VIRGINIA ELECTRIC AND POWER COMPANY (DOMINION)
SURRY POWER STATION UNIT 2
CYCLE 19 CORE OPERATING LIMITS REPORT

CORE OPERATING LIMITS REPORT
Surry 2 Cycle 19 Pattern AM
Revision 0

Dominion Topical Report
VEP-FRD-42 - Rev. 2.1-A
Reload Nuclear Design Methodology

RAI Questions and Responses Set # 1

N1C16 Flux Map 3 (100% Power ARO) FQ
Measured versus PDQ

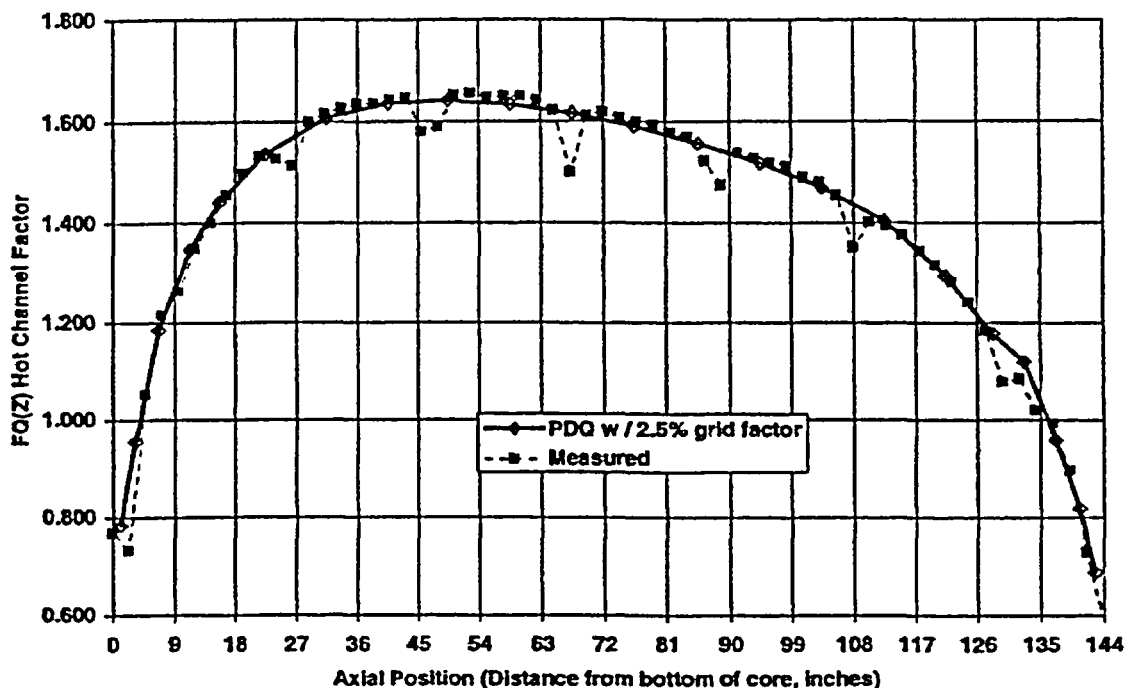
NRC PDQ QUESTION 2
